**RE: Glendesto Subdivision**  
**Revised Grading Plan Stamp Date: 1/23/18**  
**Drainage Report Stamp Date: 7/7/17**  
**Hydrology File: B18D020**

**Re: Glendesto Subdivision – (DRB 1004472) B18-D020  
Revised Grading Plan (Eng Stamp 1-23-18)**

**RE: Glendesto Subdivision  
Grading Plan and Drainage Report  
Engineers Stamp Date: 7/7/17  
Hydrology File: B18D020**

**RE: Glendesto Subdivision  
Grading Plan and Drainage Report  
Engineers Stamp Date: 6/15/17  
Hydrology File: B18D020**

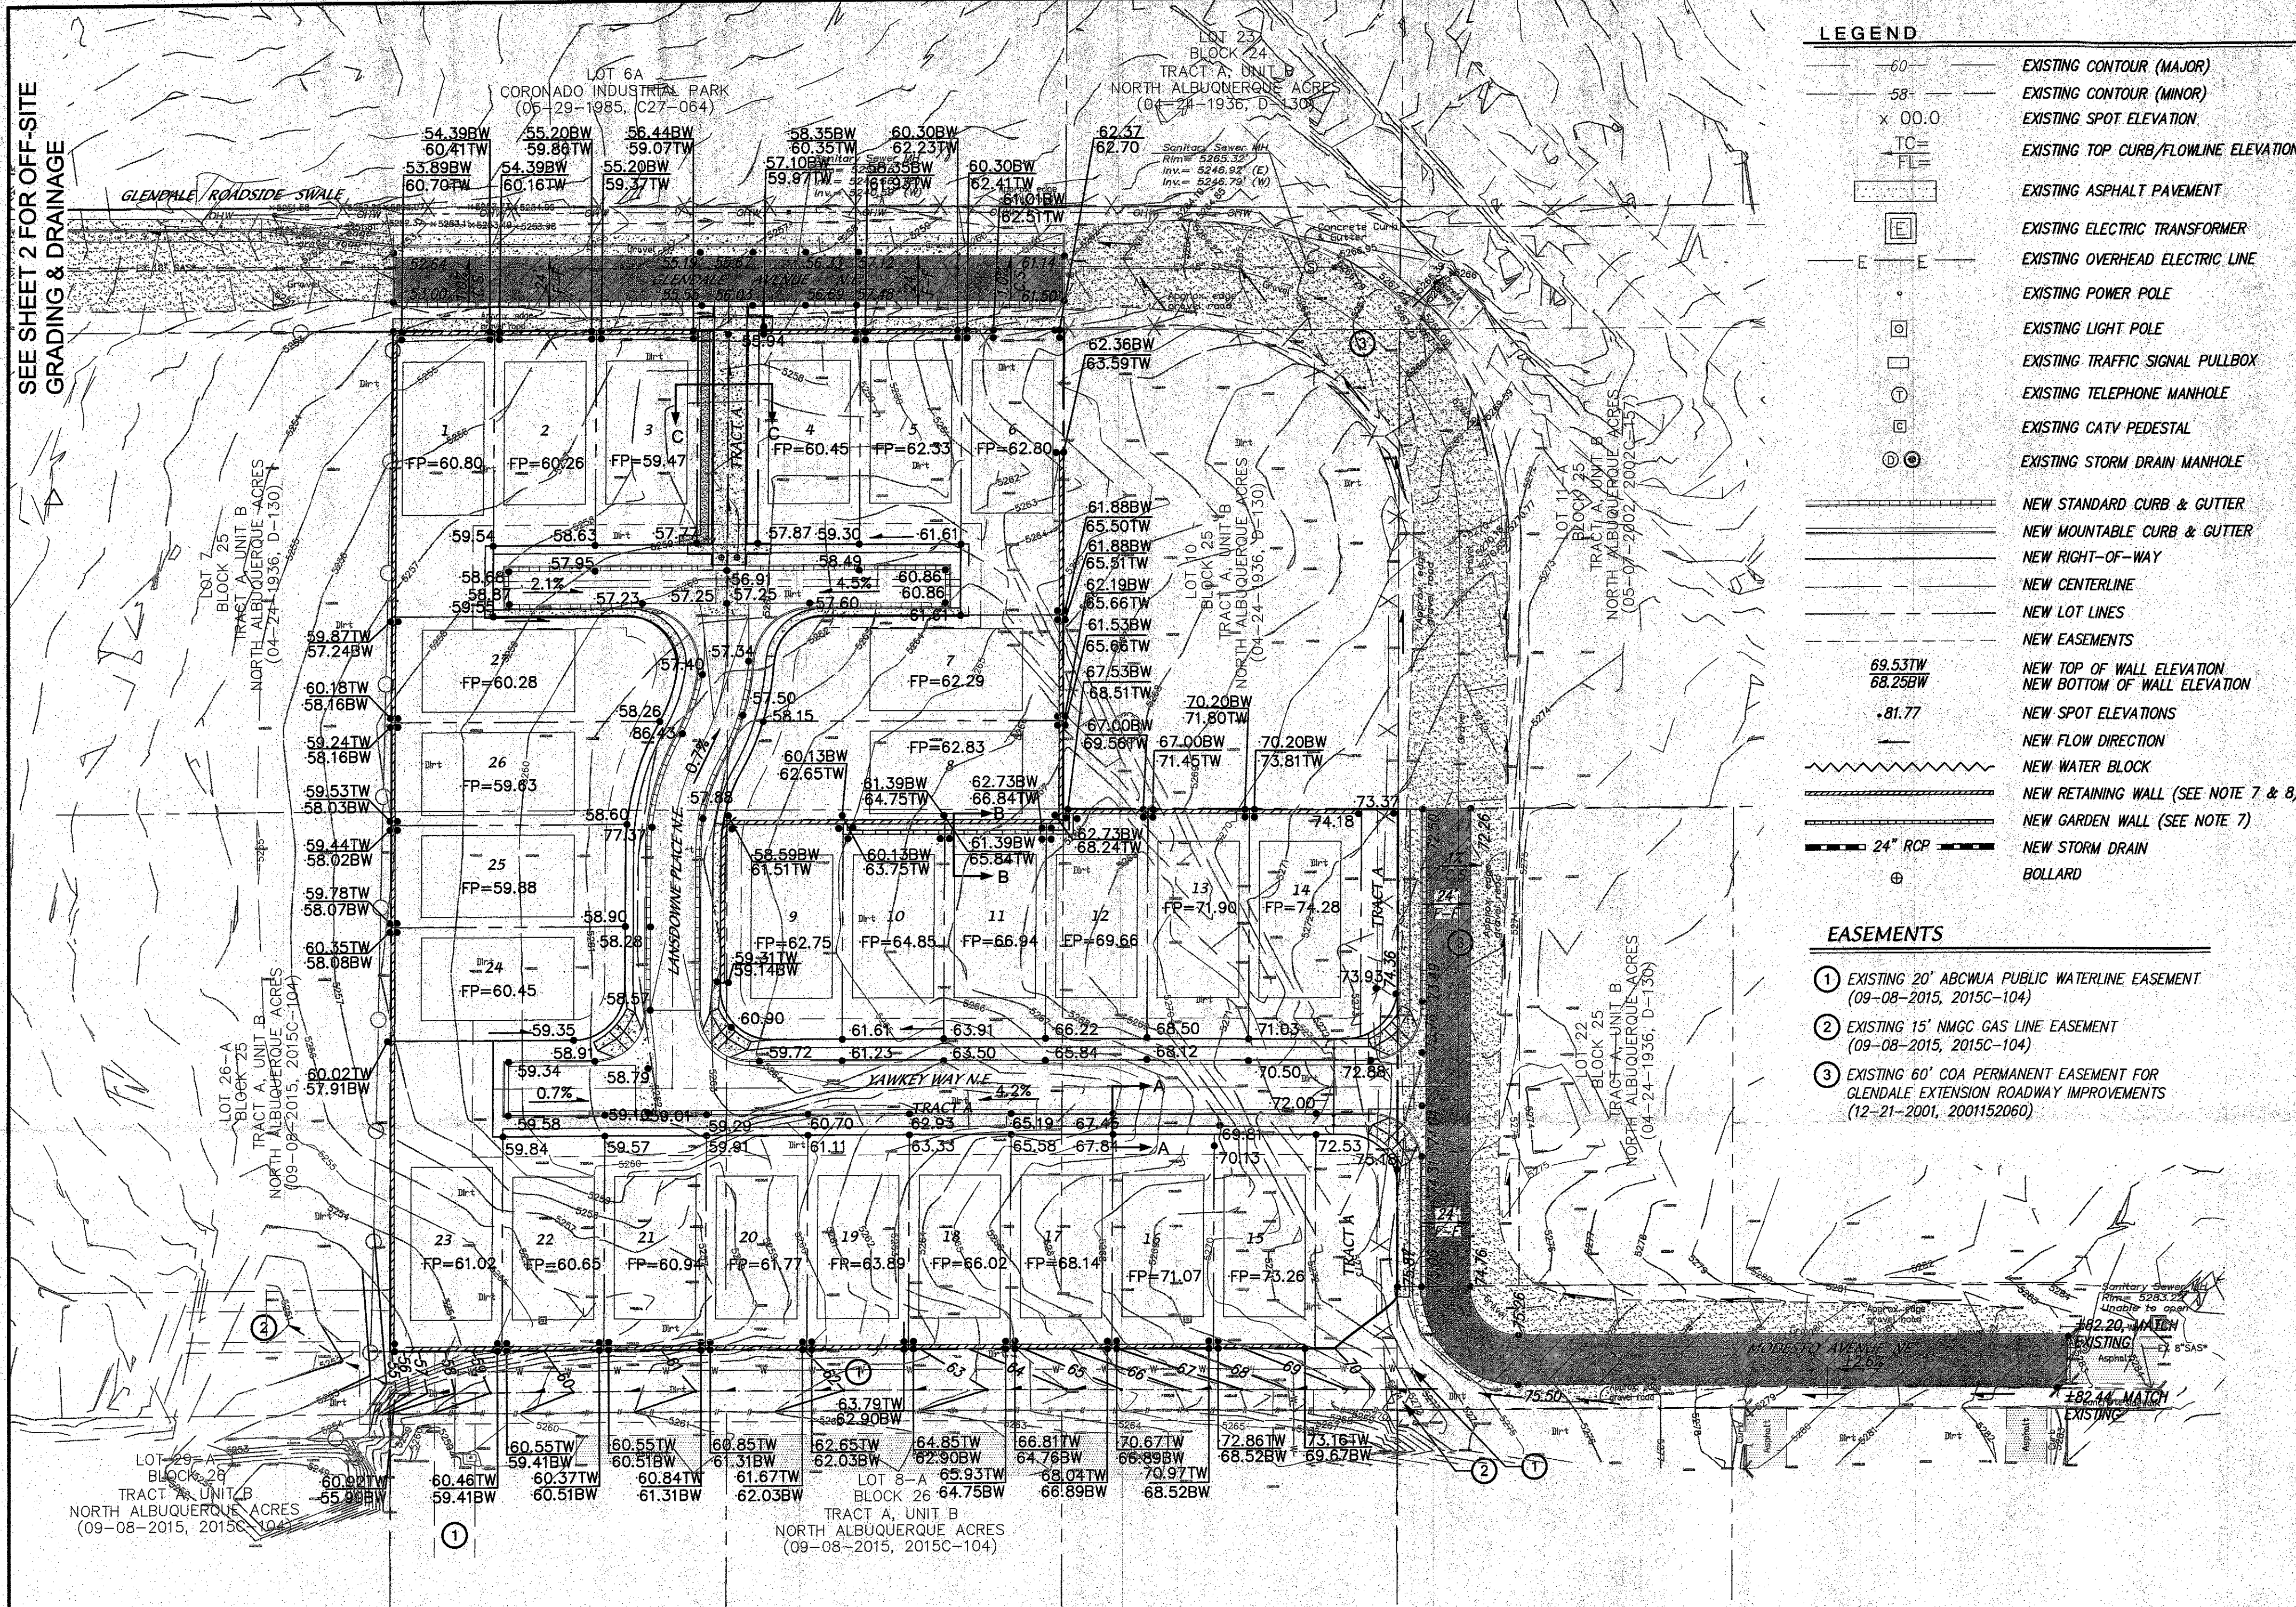
The primary revision in this grading plan is a result of the change in the entrance road configuration and width.

Based on the information provided in your submittal received on 1/24/18, the revised Grading Plan and the Drainage Report are re-approved for Grading Permit. The adjustments to Tract A have no significant impact on drainage and Hydrology has no reason to require an amended preliminary plat for it.

TITLE: **GLENDESTO SUBDIVISION  
GRADING & DRAINAGE PLAN**

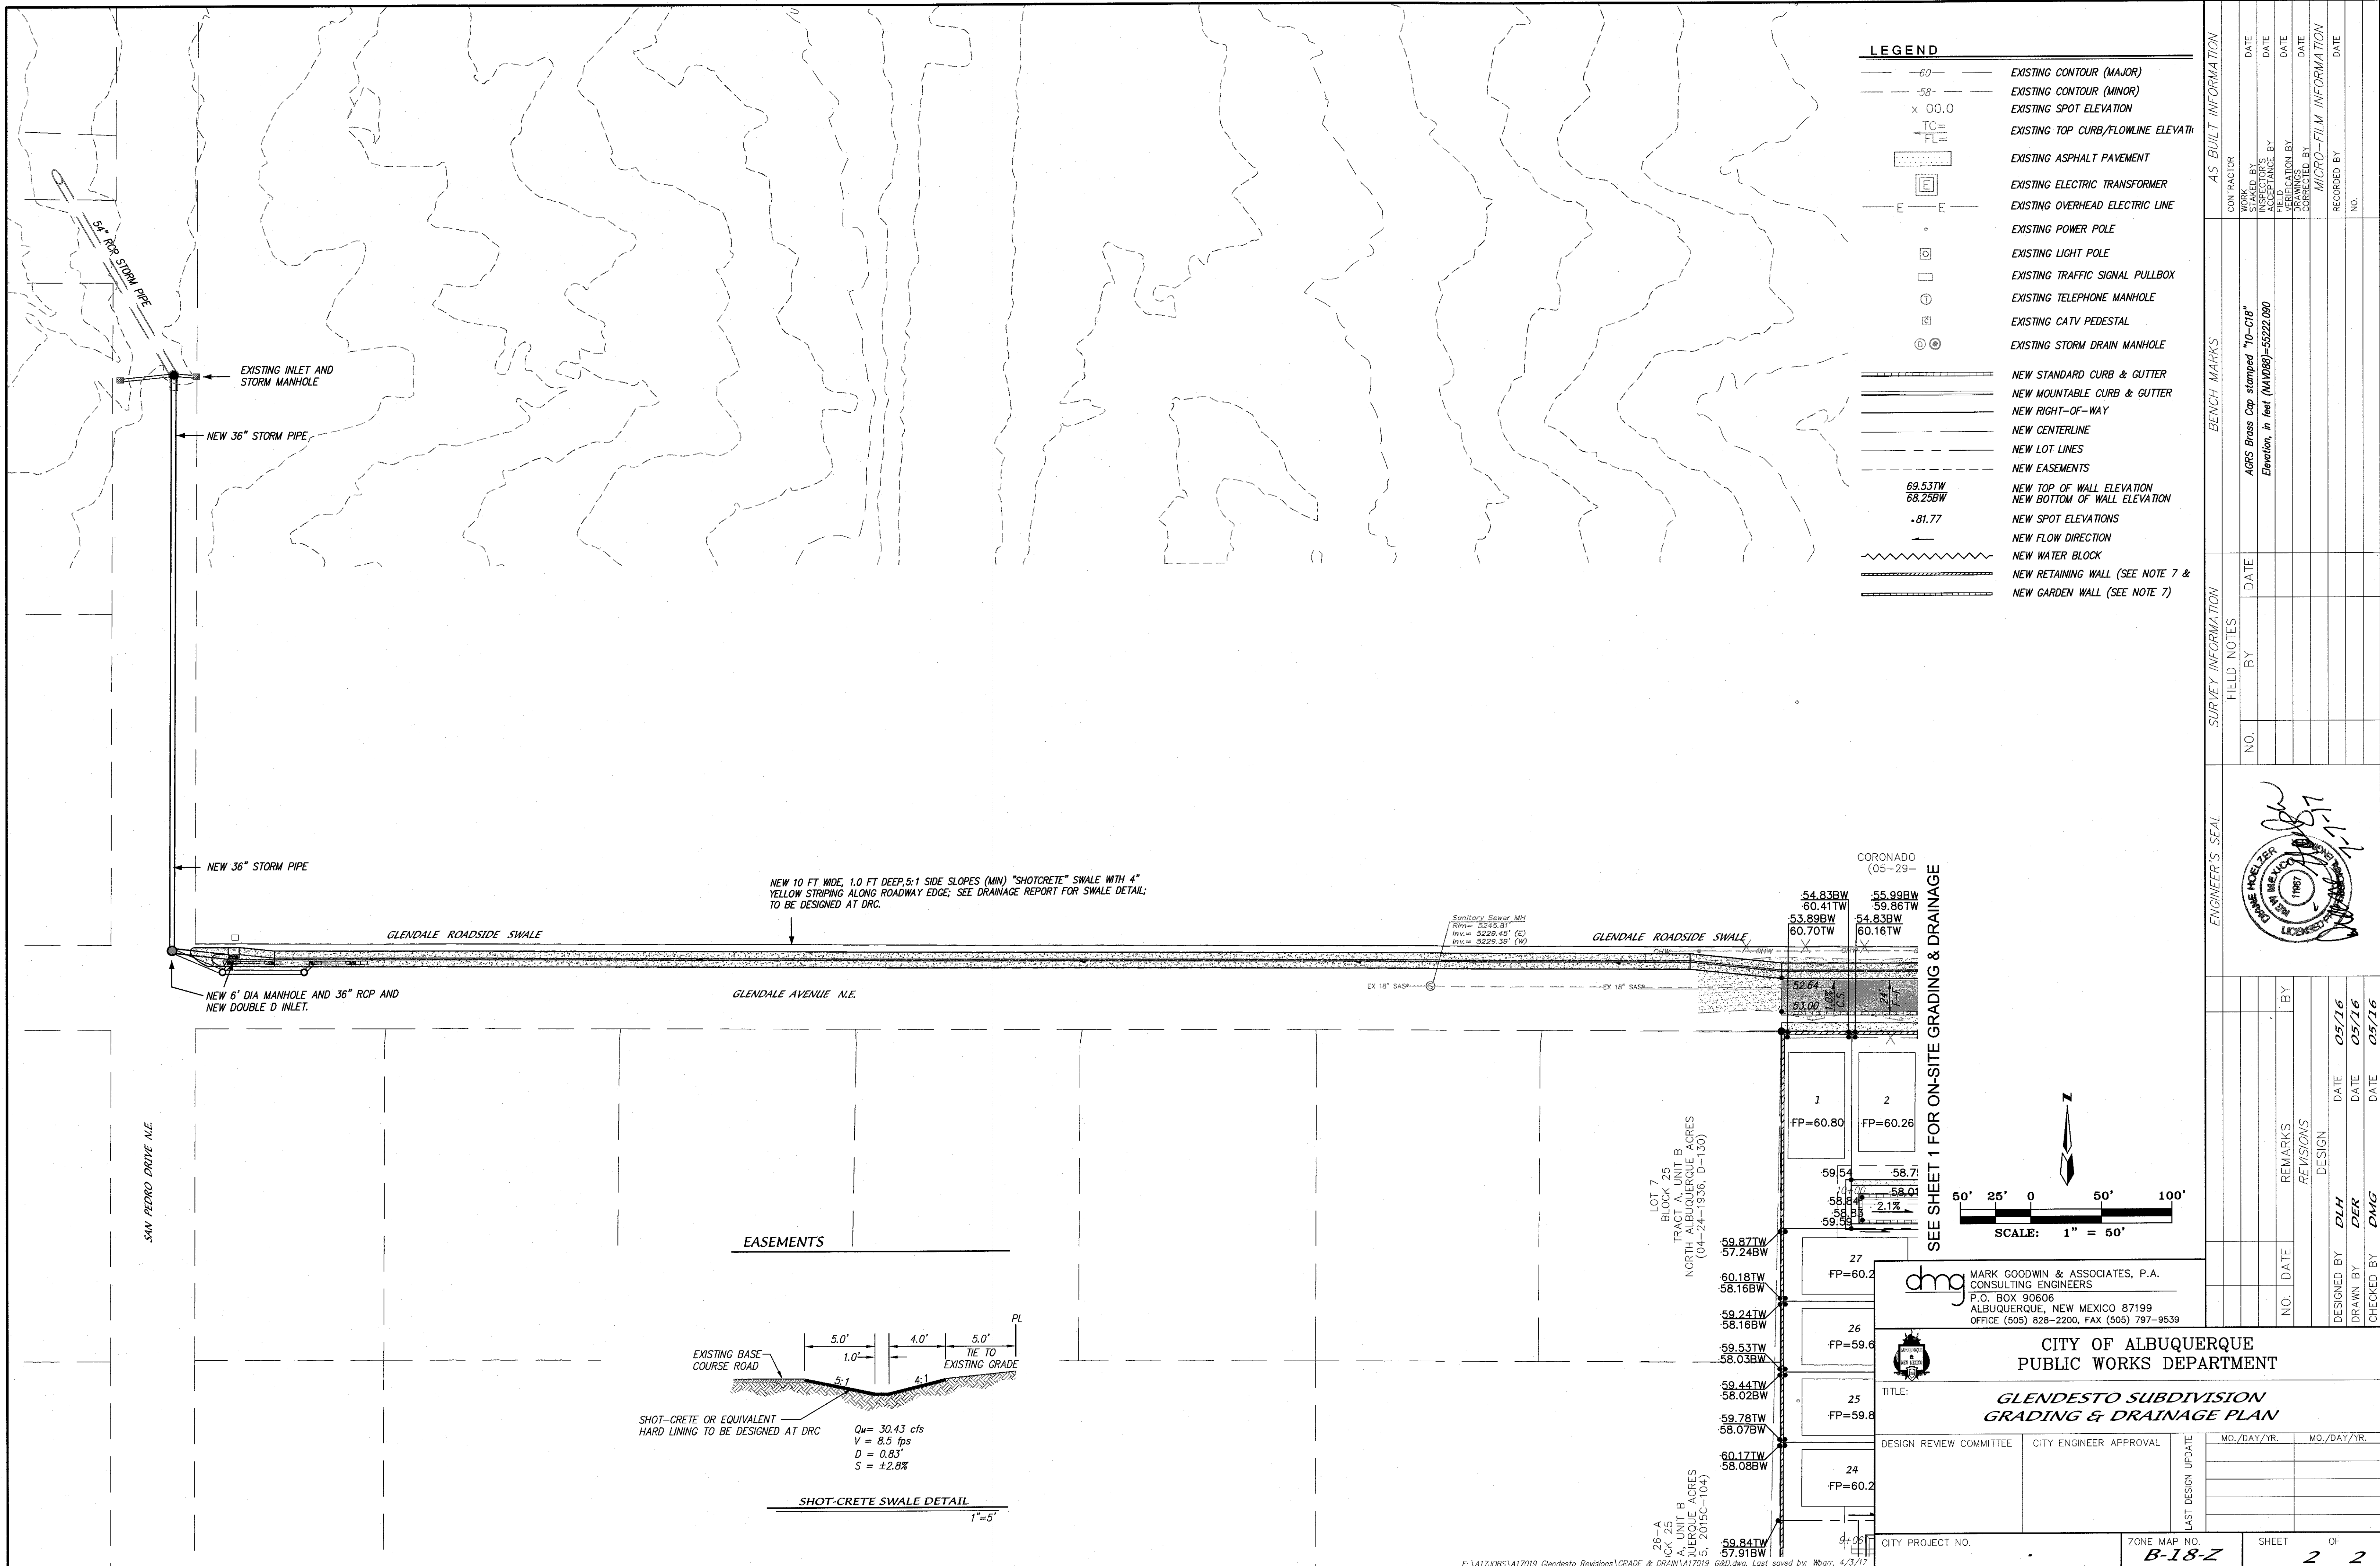
1. The proposed channel on Tract A needs to be designed to accommodate 1.0' freeboard according to Ch. 22 of the DPM. Also the channel top width in the drainage report is 9' wide, but the top width shown on the grading plan is only 5' wide.

2. What happens where the Tract A channel crosses the sidewalks on Glendale and at the hammerhead? It seems like arrays of sidewalk culverts need to be sized and designed here and included on the Infrastructure List.

3. The Glendale roadside channel designed in the drainage report does not match the channel shown on the plans.
4. What happened to the double retaining wall along the west side of lot 23, formerly lot 8? The single retaining wall topped with a garden wall will exceed the 8' maximum and the double wall may infringe on the 5' setback for the pad.

5. Recheck the pad elevations. Many pads have enough elevation difference to require retaining walls in between lots such as: lot 21, and lot 24/25.
6. A revised ESC plan is required prior to Grading Permit approval.

1. The site was lowered to reduce retaining wall height in the southwest corner,
2. A 16' wide drainage channel was placed down the middle of the 30' wide easement,
3. The drainage report was revised to address the Hydrology Dept. comments,
4. A sidewalk design variance is being requested along the south side of the hammerhead street. The Transportation Engineer requested sidewalk on both sides of the hammerhead to create sidewalk continuity within the development. We are asking for a variance along the south side of the hammerhead adjacent to Lots 27 and 7 because if the landscape easement is added there will not be enough width within the lot for the home product planned for this development. The lot depths adjacent to lots 7 and 8 along Yawkey Way are already at a minimum depth of 105 feet.
5. A sidewalk waiver along lot 24 is being requested as well.
